1017 BARRENJOEY RD. PALM BEACH **DEVELOPMENT APPLICATION NO. DA N1118/00** CONSTRUCTION CERTIFICATE NO. 23250/1

CONSTRUCTION CERTIFICATE NO. 23250/1

> Peer Review of Defire Pty Ltd Alternative Solution Report 03164 R1.2 RE: 1017 Barrenjoey Road, Palm Beach, NSW

UNIT 4 (FIRST/SECOND)
-Reduce worlshop window length on SW elevation CTY PLAN 1
-Vent ple modified.
-Reconfigure office windows. "CITY PLAN SERVICES Construction Cert. No: Approved Date: Accreditation No: The Boatshed 1017 Barrenjoey Rd Palm Beach NE/SW Elevations 1:100

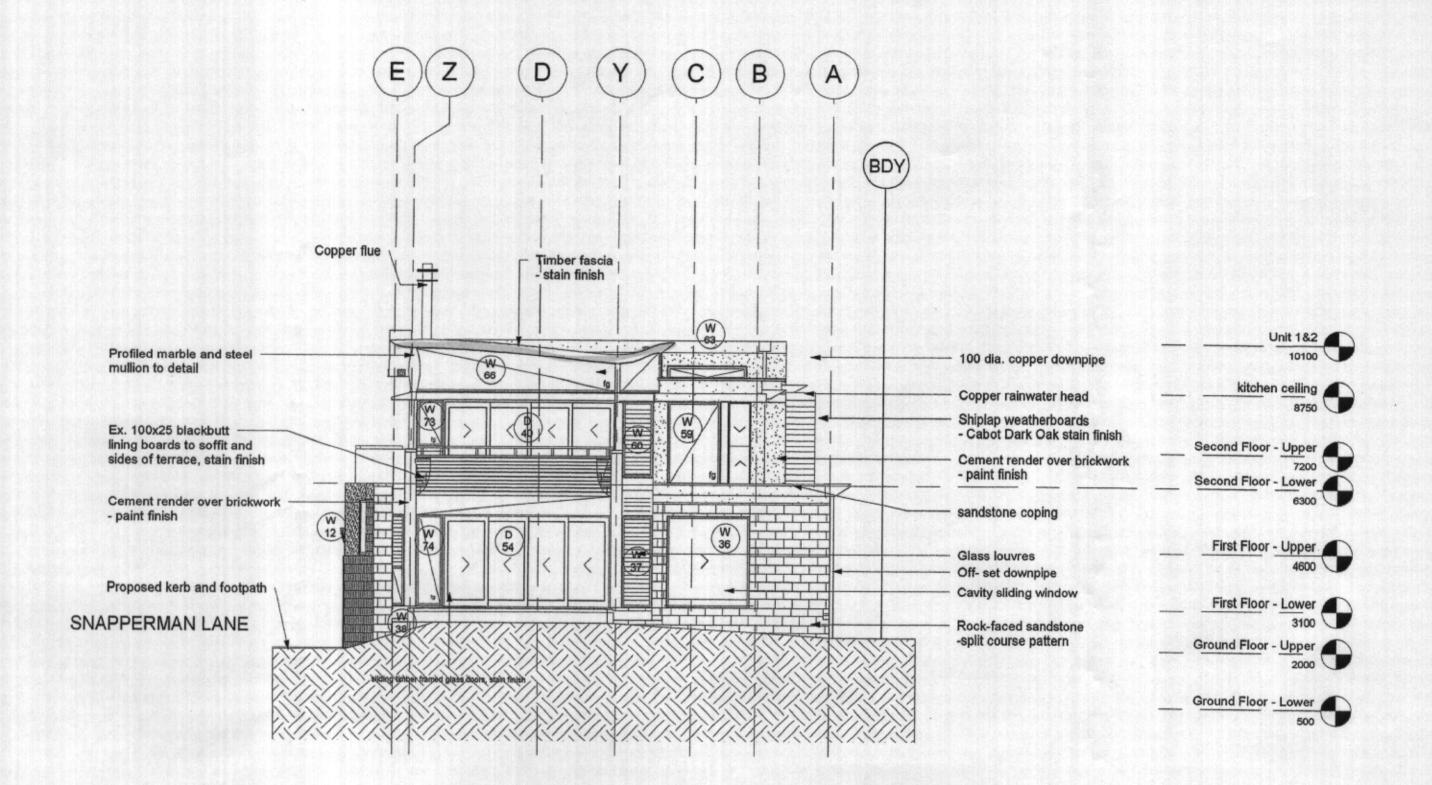
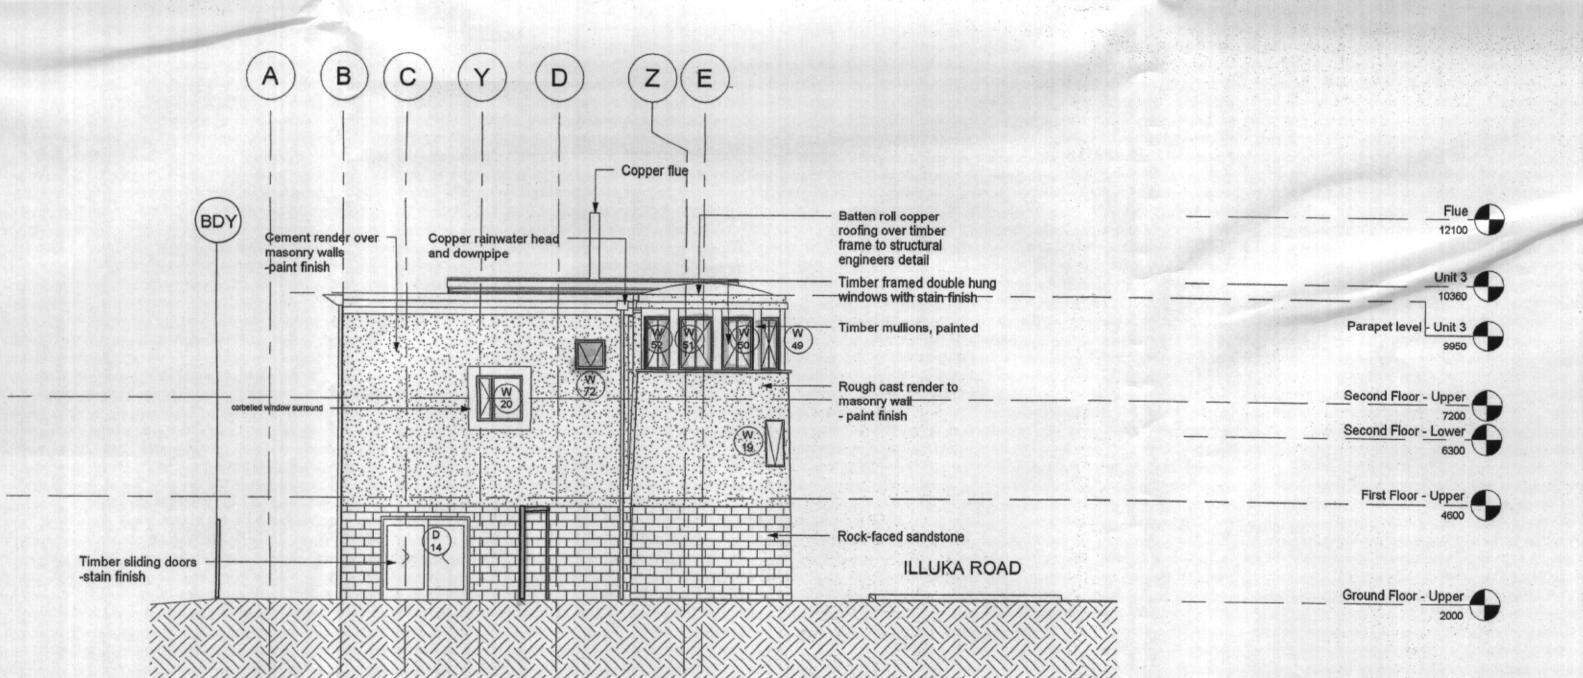
-Additional ventilation grills to Sth wall of Basement for plant room requirements.
-Place double sliding doors x3 to bin storage area.

UNIT 3 (GROUND FLOOR)
-Change fence to Unit 3 to brushwood.
-Reduce length of sliding door to Ancillary room.
-Replace door on StE boundary to Ancillary room with window.

UNIT 1 (FIRST FLOOR)
-Replace window in study with double door.
-Relocate window in StE wall.
-Add fixed glass window in N/W wall at first floor stairs.
-Reconfigure timber trellis.

UNIT 2 (SECOND FLOOR)
-Addition of a glass roof adjacent to dining room.
-Reconfigure Kachendining roomroof slab to include laundry and powder room.
-Add skylights to roof above hallway.
-Delete step in roof above hallway.
-Delete step in roof above bedrooms.
-Reposition of windows to StE boundary.
-Reconfigure copper roof.

UNIT 3 (FIRST/SECOND FLOOR)
-Relocate window position in S/E wall.
-Extend deck toward kitchen at living room.
-Add window to bed 2 en suits.
-Frovide stone inlay to unit 3 balustrade.
-Change window type in turnet.

DEVELOPMENT CONSENT 101

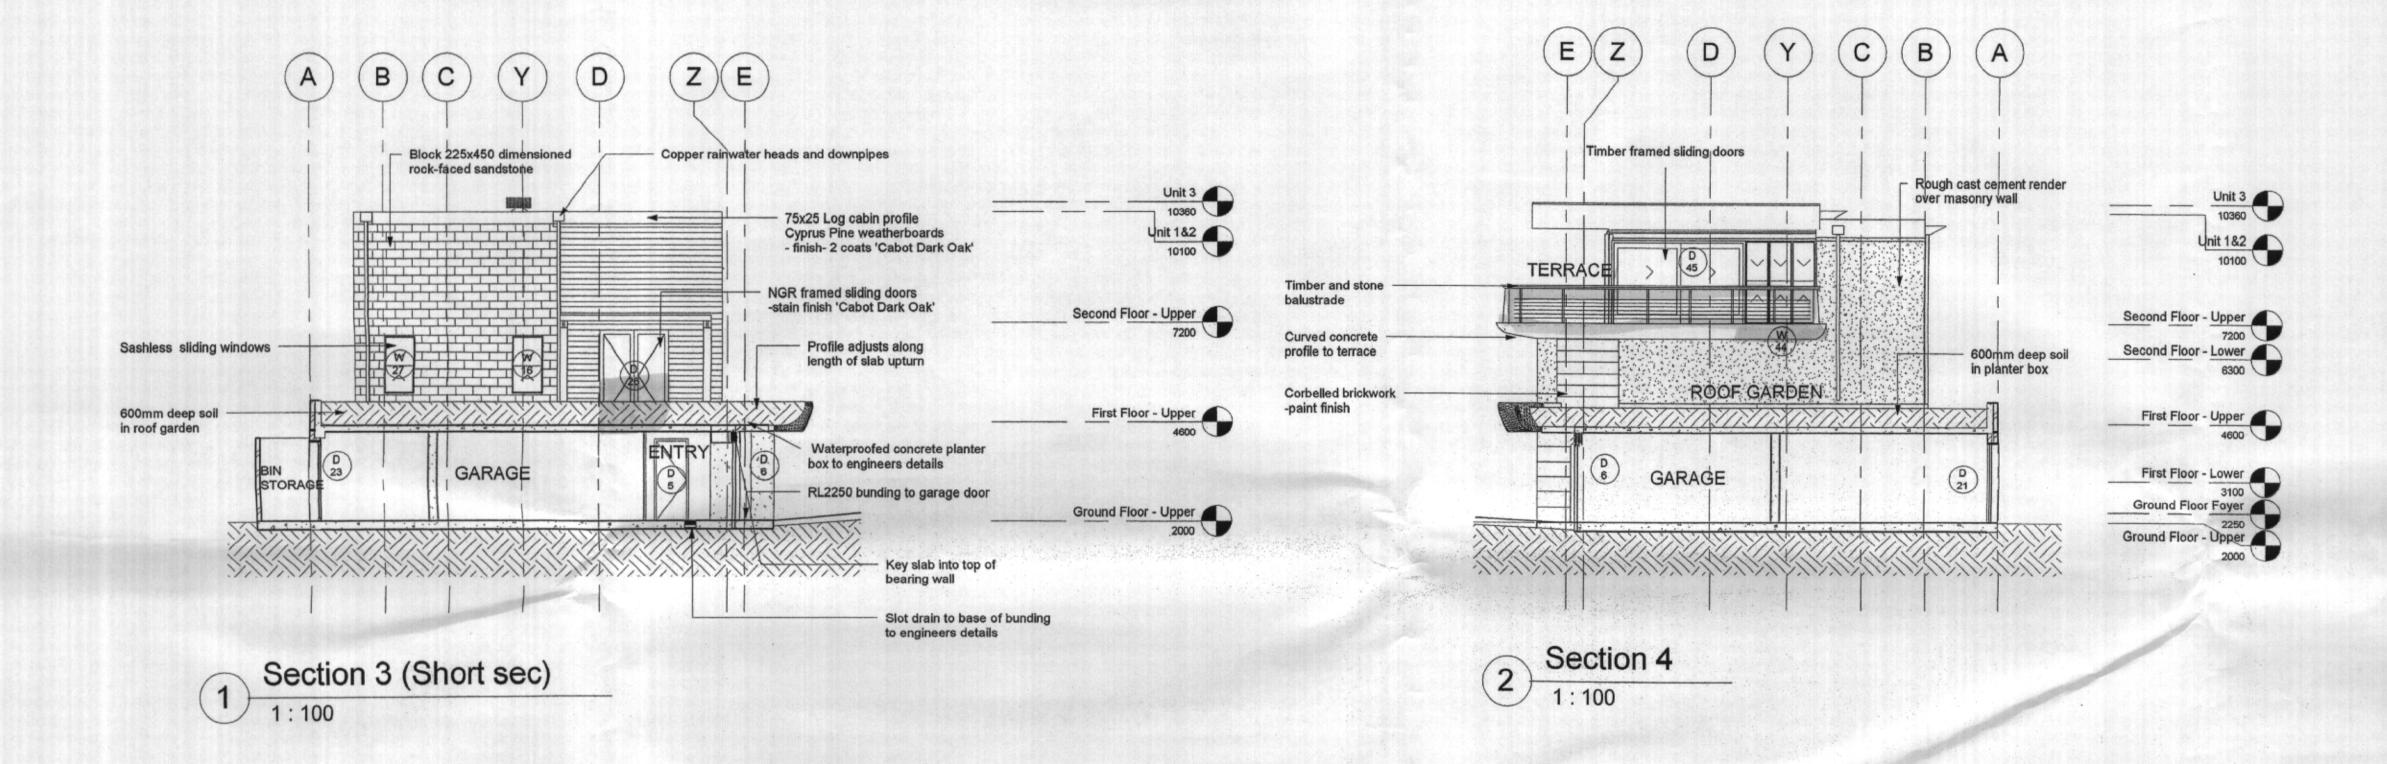
-Additional ventilation grills to Sth wall of Basement for plant room requirements,
-Place double sliding doors x3 to bin storage area.

-Change fence to Unit 3 to brushwood,
-Reduce length of sliding door to Ancillary room.
-Replace door on SIE boundary to Ancillary room with window.

-Replace window in study with double door.
-Relocate window in study with double door.
-Relocate window in SIE wall.
-Add fixed glass window in NAW wall at first floor stairs.
-Reconfigure tentls.

-Addition of a glass roof adjacent to dining room.
-Reconfigure Kitchen/dining roomroof slab to include laundry and powder room.
-Add skylights to roof above hallway.
-Delete step in roof above bedrooms.
-Reposition of windows to SIE boundary.
-Reconfigure windows to copper roof (SIW elevation).
-Reconfigure copper roof.

UNIT 3 (FIRST/SECOND FLOOR)
-Relocate window position in SIE wall.
-Relocate and add window in NIE wall.
-Extend deck toward kitchen at living room.
-Add window to bed 2 en suite.
-Provide stone inlay to unit 3 balustrade.
-Change window type in turret.

UNIT 4 (FIRST/SECOND)
-Reduce workshop window length on SIW slevation.
-Vent pipe modifiled.
-Reconfigure office windows. Watton CITY PLAN SERVICES Construction Cert. No: Approved Date: Accreditation No: PIA3004 The Boatshed
